Re: TVC 2050 Project (Case Numbers VTT-83387; CPC-2021-4089-AD-GPA-ZC-HD-SP-SN; CPC-2021-4090-DA; and ENV-2021-4091-EIR, collectively the “Project”)

Detailed Analysis of Concerns with EIR, Specific Plan

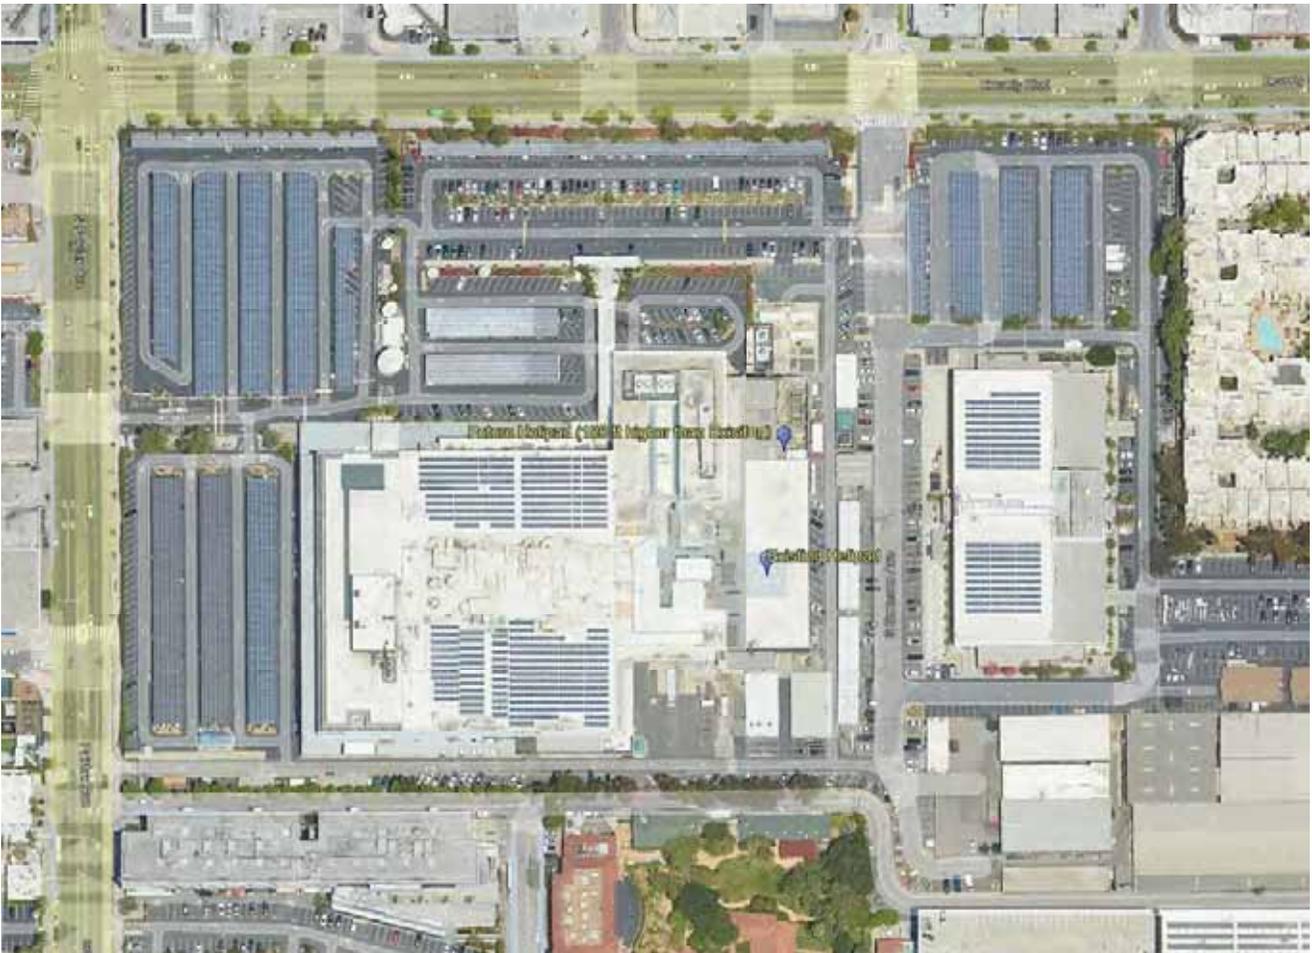
The vertical displacement data suggest a downward displacement of up to 1 foot at the location.

**Figure 3 – Example of Left-Turning Truck Trapped in Intersection for Extended Period
And Conflicting with Pedestrians (with Traffic Control Officer)
6:57 through 6:59 PM on December 22, 2023**

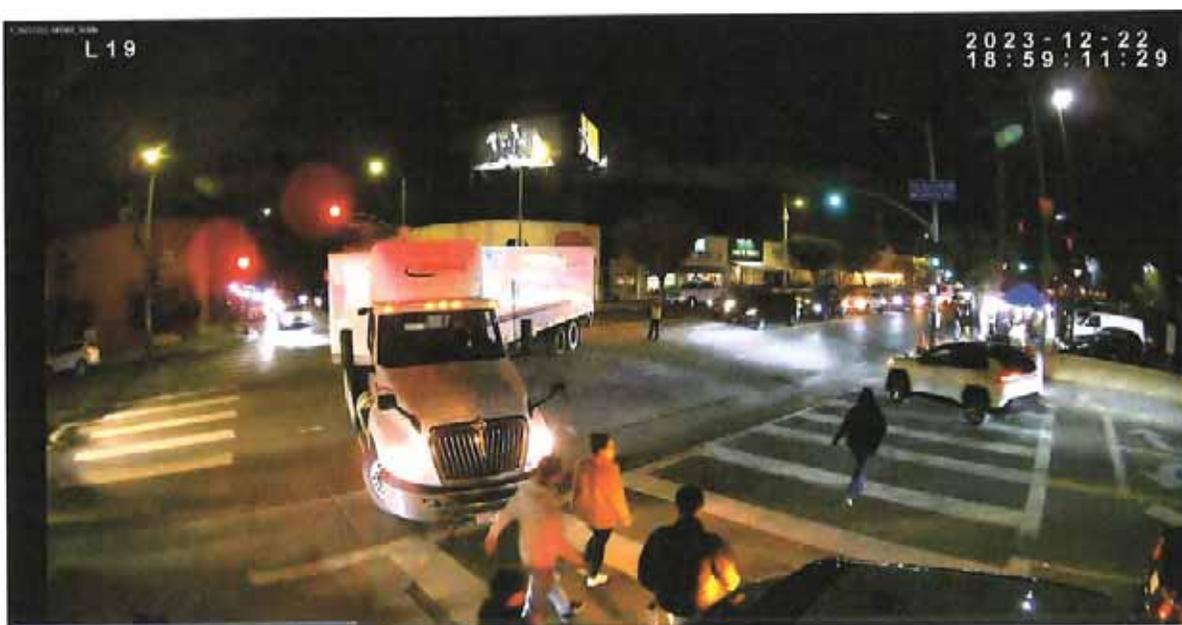
Figure 3 above comprises two images from the video recordings captured on December 22, 2023, at 6:57 p.m. and 6:59 p.m. **Figure 3** shows a hazardous condition of a left-turning truck trapped in the Grove Drive / Beverly Boulevard intersection caused by the temporary reduction of travel lanes on The Grove Drive. The installation of a new traffic signal at the TVC Project driveway will cause this same unsafe traffic hazard. In addition to illustrating the same issues highlighted in **Figure 1** and **Figure 2** (i.e., a left-turning vehicle trapped in the intersection blocking eastbound Beverly Boulevard traffic and resulting in hazardous conflicts with pedestrians in the crosswalk, which an LADOT traffic control officer is unable to prevent), **Figure 3** highlights a recurring observation that vehicles trapped within the intersection did so over an extended length of time (in this case, at least two minutes), and was not a momentary inconvenience or cause for delay.

Figure 5 – Example of Pedestrians Forced to Walk Outside of Crosswalk Due to Vehicles Trapped in Intersection 6:29 PM on December 23, 2023

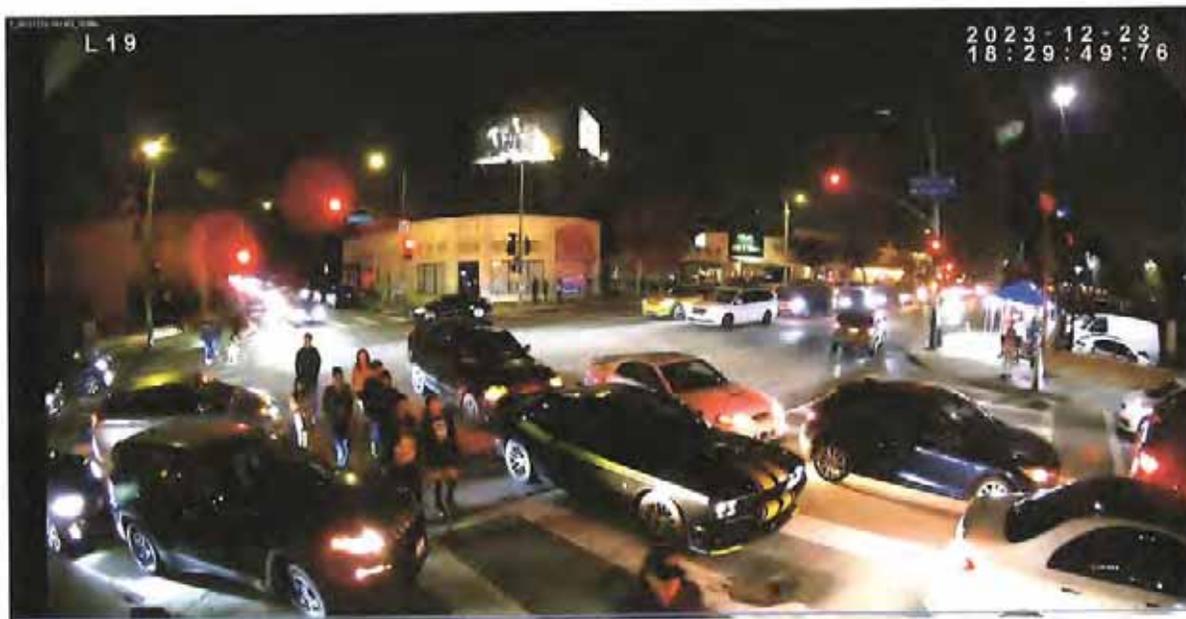
Finally, **Figure 5** below documents another hazardous condition frequently observed at the Grove Drive / Beverly Boulevard intersection in December 2023 created by the temporary lane closure. As seen in the image from the video recordings, the high number of vehicles trapped within the intersection caused by the lane drop condition on Grove Drive occasionally forced pedestrians to cross outside of the marked crosswalks. Specifically, **Figure 5** shows approximately eight pedestrians attempting to cross the west leg of Beverly Boulevard, but outside of the marked crosswalk and forced to navigate through the trapped vehicles as they are attempting to access southbound Grove Drive. These motorists were likely not aware of the pedestrians walking outside of the crosswalk, with the hazards further exacerbated in this image by the nighttime conditions and therefore reduced visibility. A new full-time traffic signal on The Grove Drive at the TVC Project driveway, with red traffic signal indications repeatedly stopping southbound traffic on The Grove Drive throughout daytime and nighttime conditions, will replicate these documented hazards caused by the TVC Project which have not be analyzed or disclosed in the Final EIR.

FIGURE 6A-1
TRUCK MANEUVERING ANALYSIS - INBOUND
AASHTO (US) WB-40
TVC 2050 Project

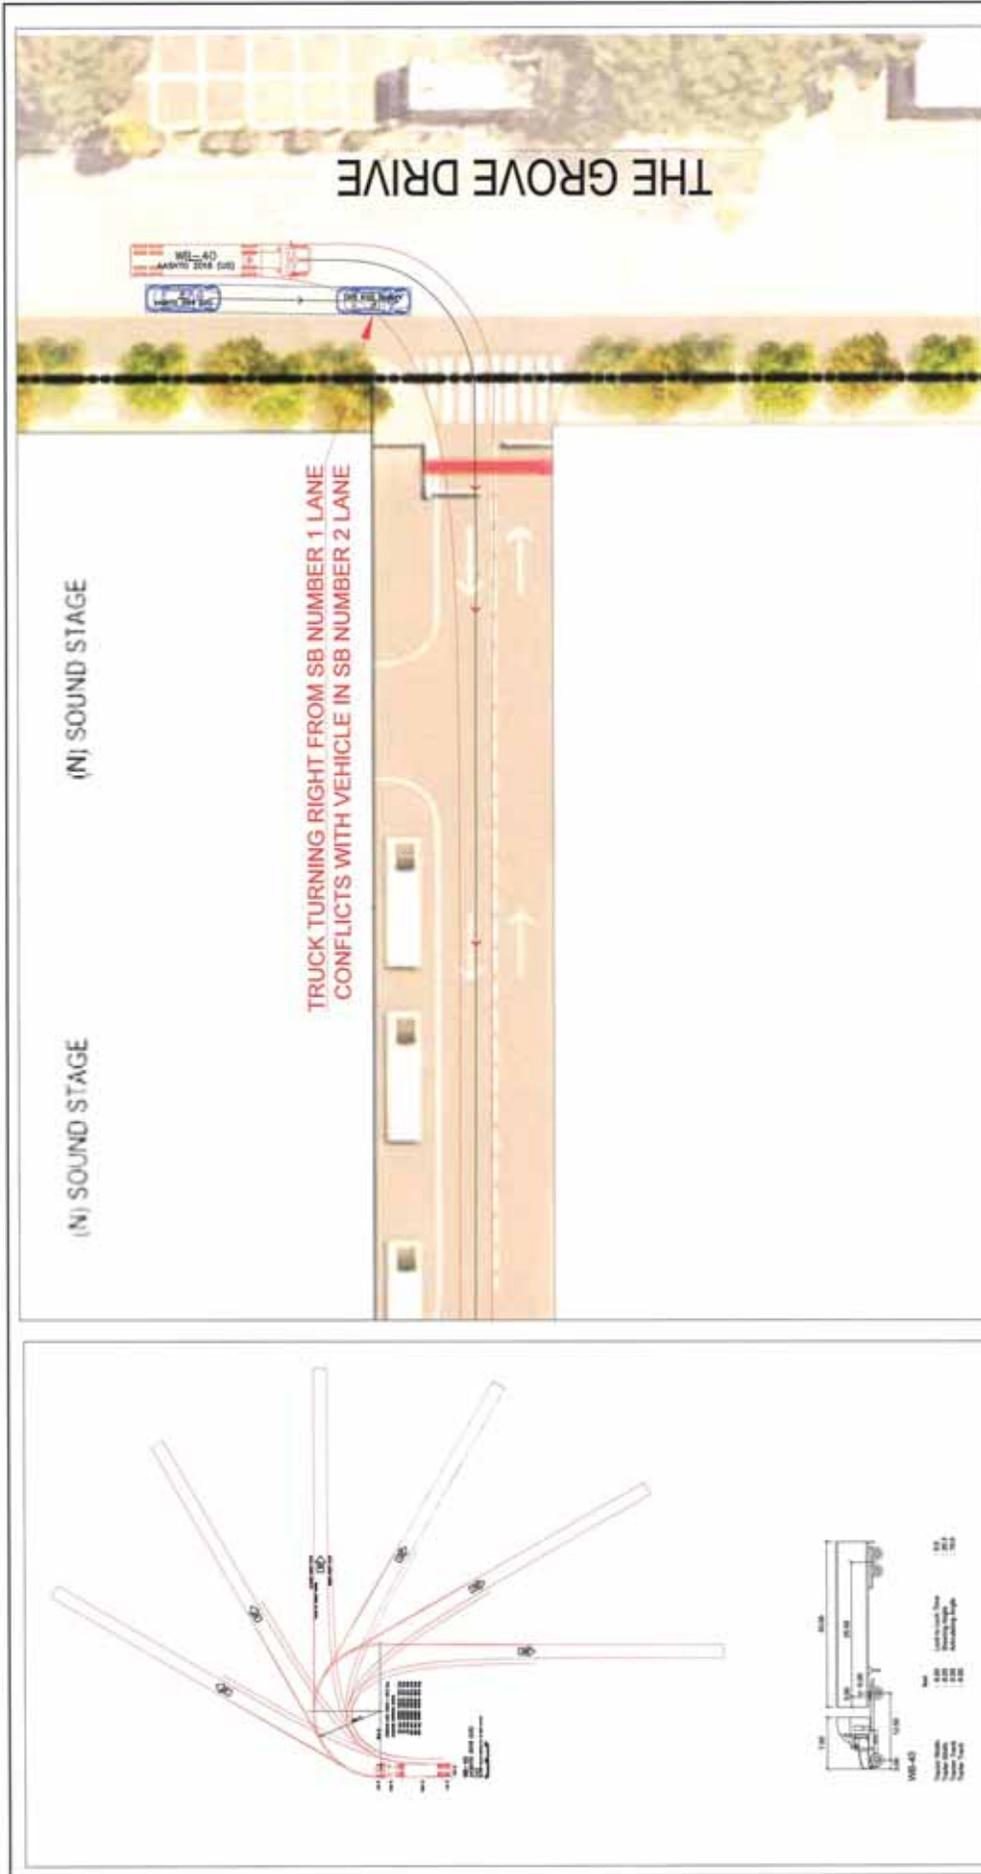
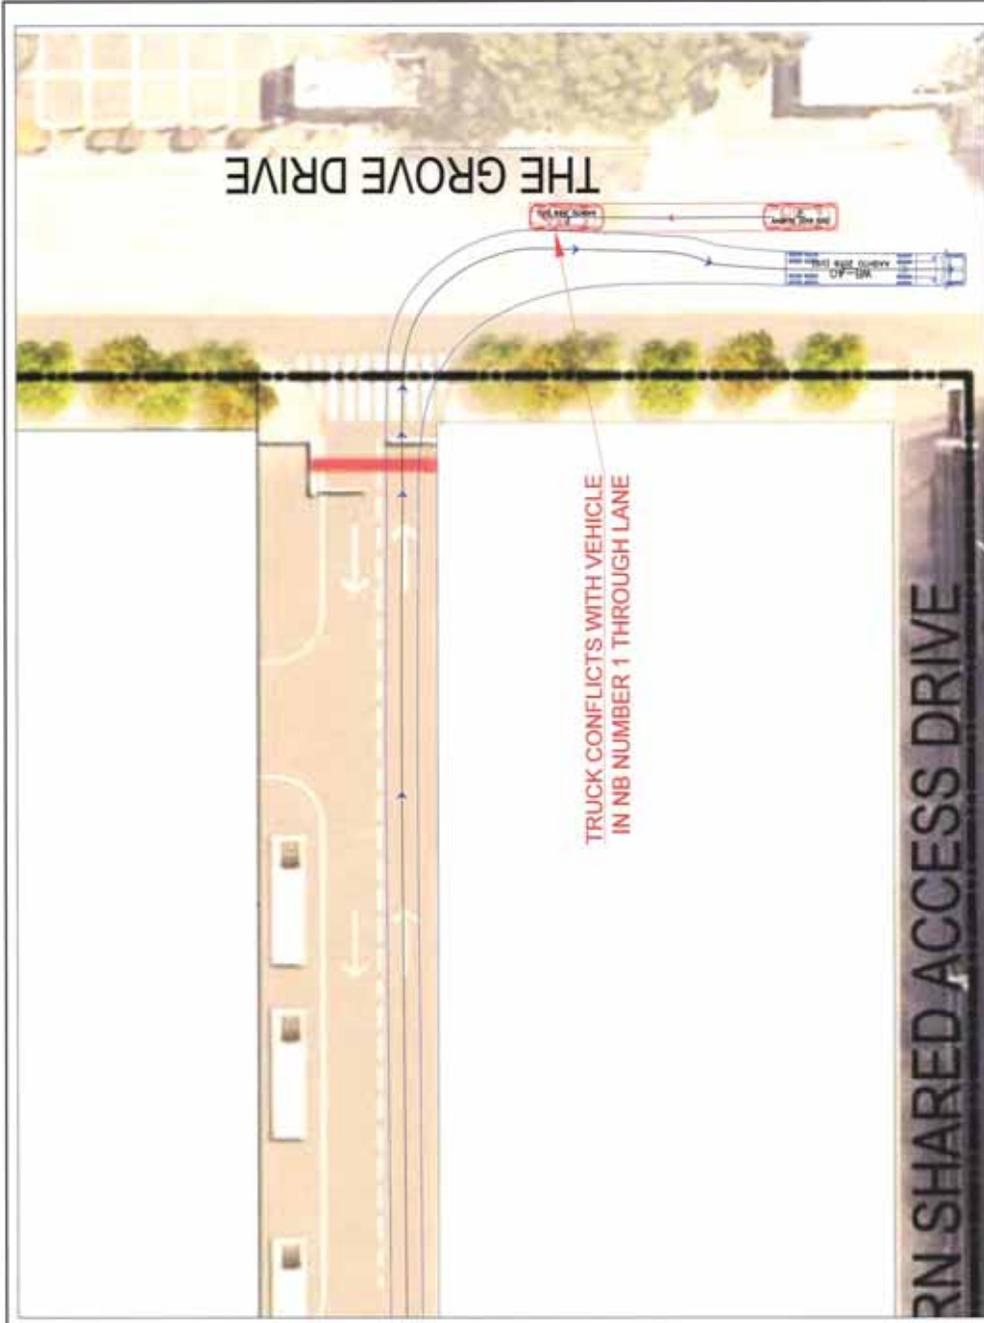
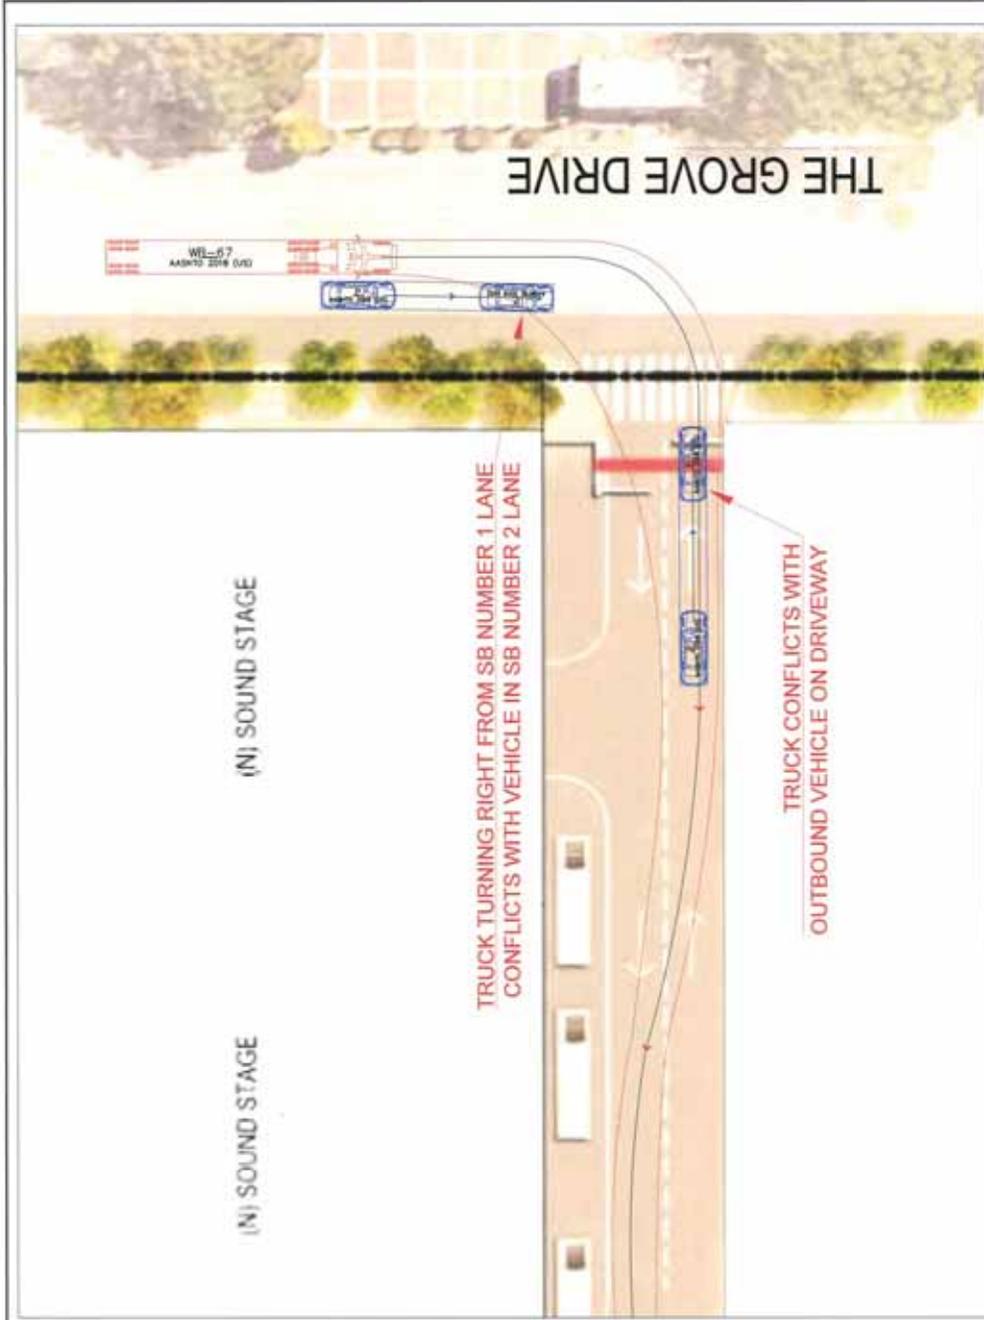
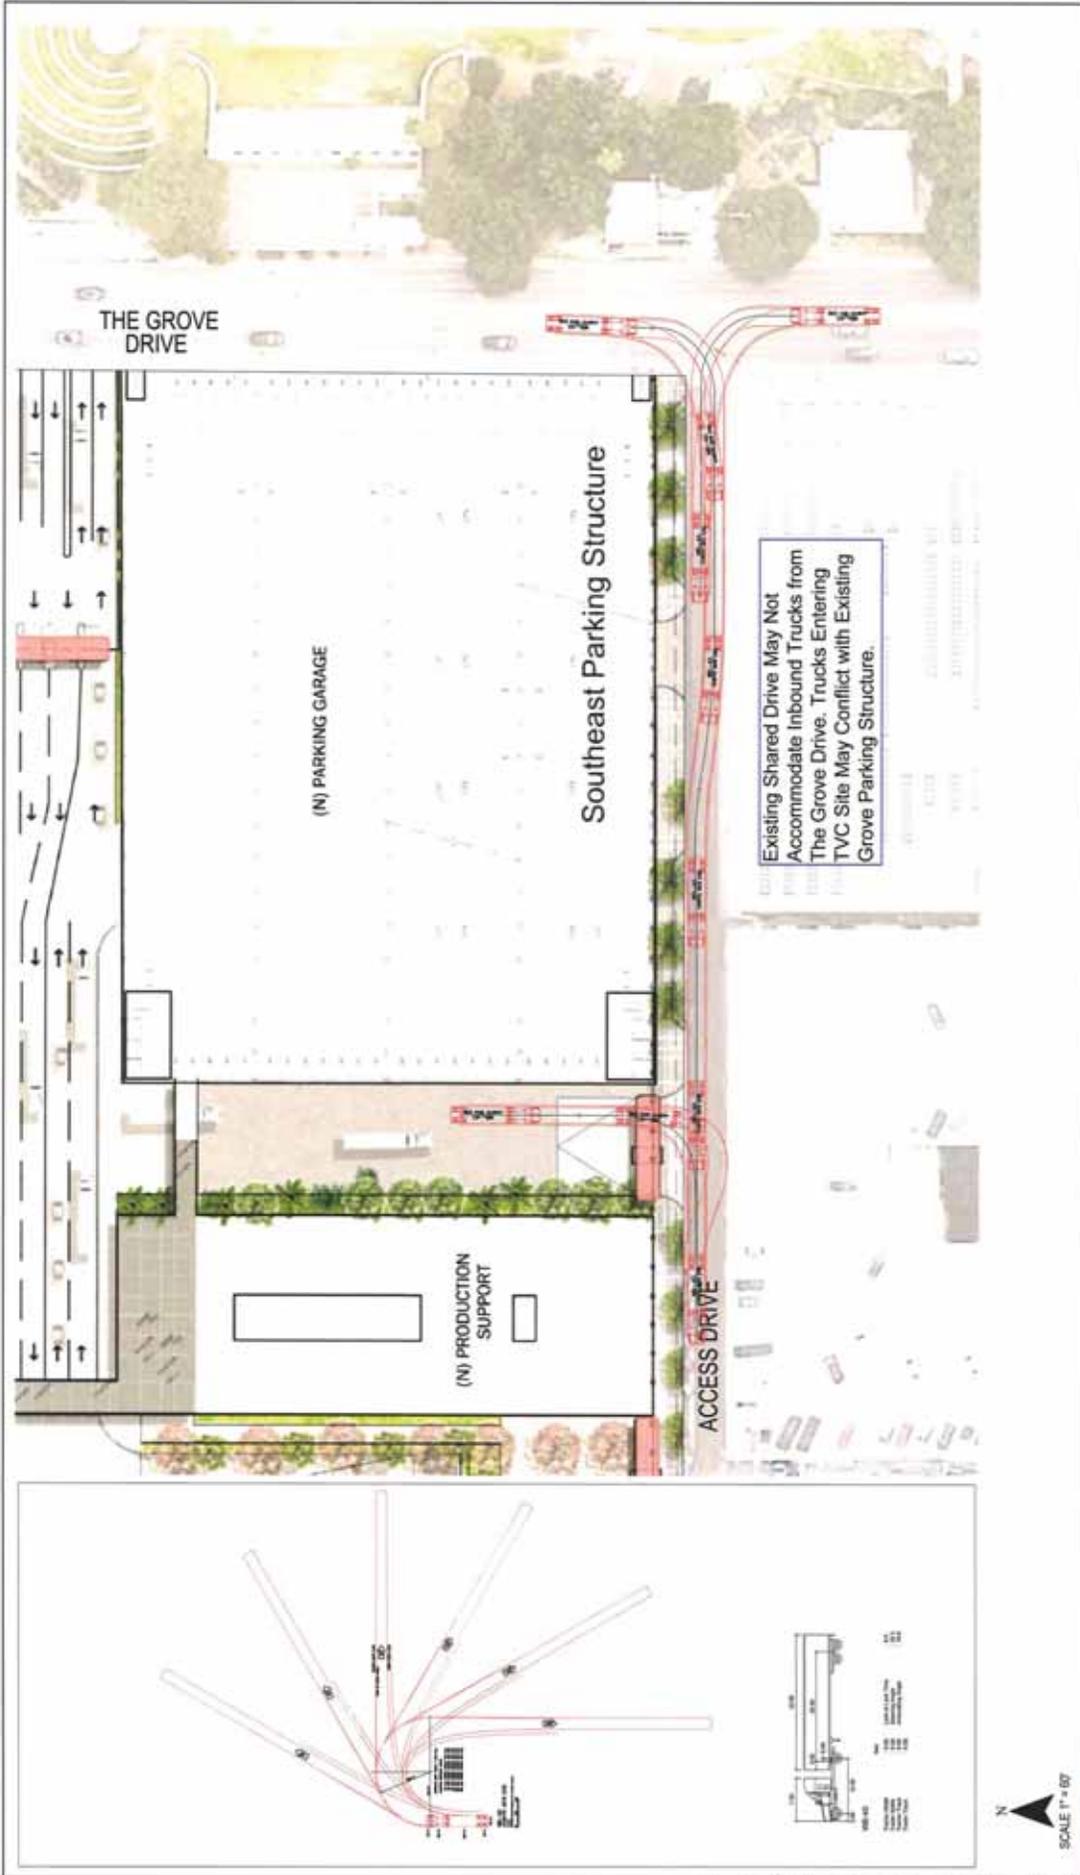
Figures II-11 and II-12 in the Final EIR are misleading. Both figures only depict trucks (WB-40 and WB-67, respectively) turning to and from the TVC Project’s proposed truck driveway via left-turns to and from The Grove Drive. If the figures had been properly prepared to show right-turns (instead of left-turns) to and from the new truck driveway, the results would have been similar to the analysis provided by LLG attached to this memorandum, which demonstrates that trucks

Further, as previously noted, Figures II-11 and II-12 provided in the Final EIR (related to Response to Comment No. 26-E.4-15) are highly misleading and incomplete because they show trucks turning left to and from the TVC Project driveways on The Grove Drive. By contrast, Figure 11 in the Final EIR's Erratum No. 1 shows that the new TVC Project truck access driveway on The Grove Drive would accommodate right-turn movements only (right-turns in and right-turns out), which require a great amount of roadway space to complete as compared to the misleading left-turn only movements shown in Figures II-11 and II-12.
